| Project        | <b>IEEE 802.16 Broadband Wireless Access Working Group</b> < <a href="http://ieee802.org/16">http://ieee802.org/16</a> >   |  |
| Title          | <b>Replies to comment #105 (location information request and response messages)</b>  |  |
| Re:            | IEEE 802.16j-07/019: "Call for Technical Comments Regarding IEEE Project 802.16j"  |  |
| Purpose        | Text proposal for 802.16j Baseline Document.   |  |

Figure xxx Relay location information response procedure – RS

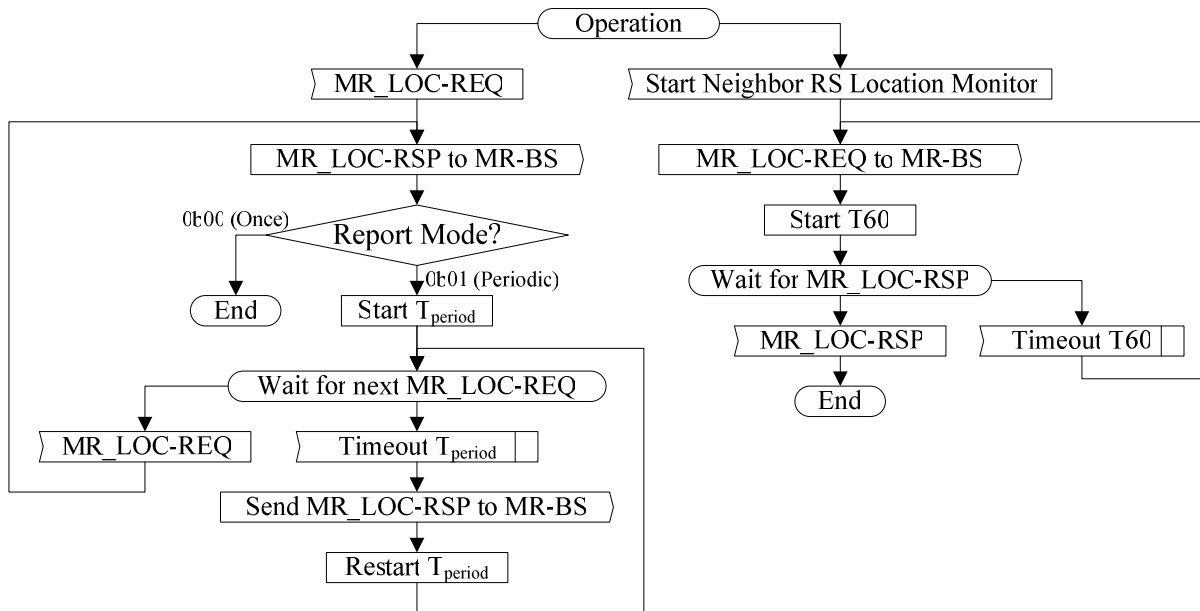
In order to assist RS neighborhood discovery, MR-BS should send an MR\_LOC-REQ message to the RS. Upon receiving the MR\_LOC-REQ message, RS shall report its location information by sending an MR\_LOC-RSP message to the MR-BS. If the MR\_LOC-REQ message containing the report type field 0b01, RS shall periodically send an RLY\_LOC-RSP message to the serving MR-BS every time interval defined by “Report period”.

The message sequences chart (Figure 40a, Figure 40c and Figure 40b) and flow charts (Figure xxx and Figure yyy) on the following pages define the RS location request and report that shall be followed by compliant RSs and MR-BSs.

Figure yyy Relay location information request procedure – MR-BS

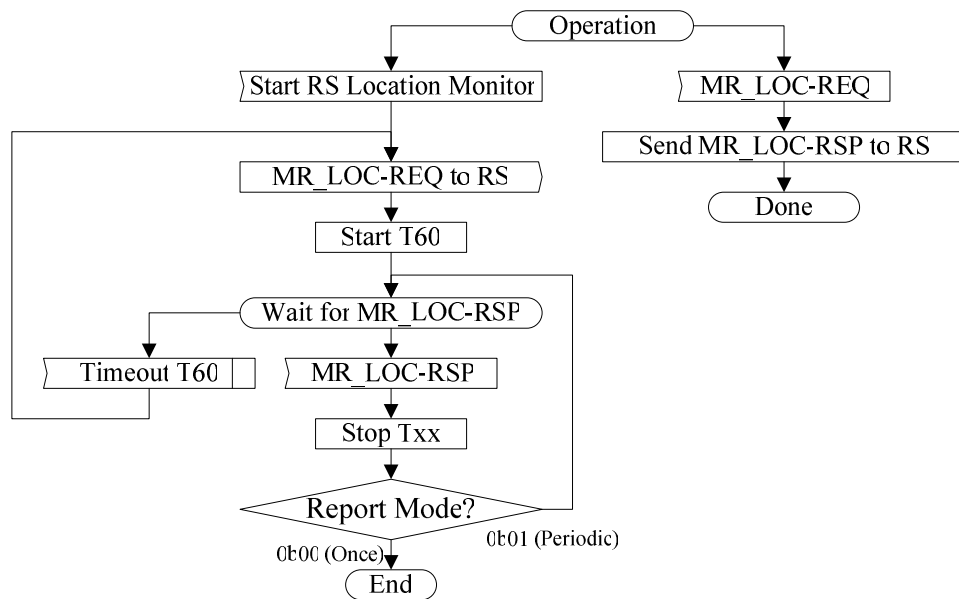
In order to obtain the location information of neighbor stations, a RS should send an MR\_LOC-REQ message containing 48-bit MAC address of neighboring stations to the MR-BS. Upon receiving the MR\_LOC-REQ message, MR-BS shall report the location information of neighboring stations by sending an MR\_LOC-RSP message to the RS.
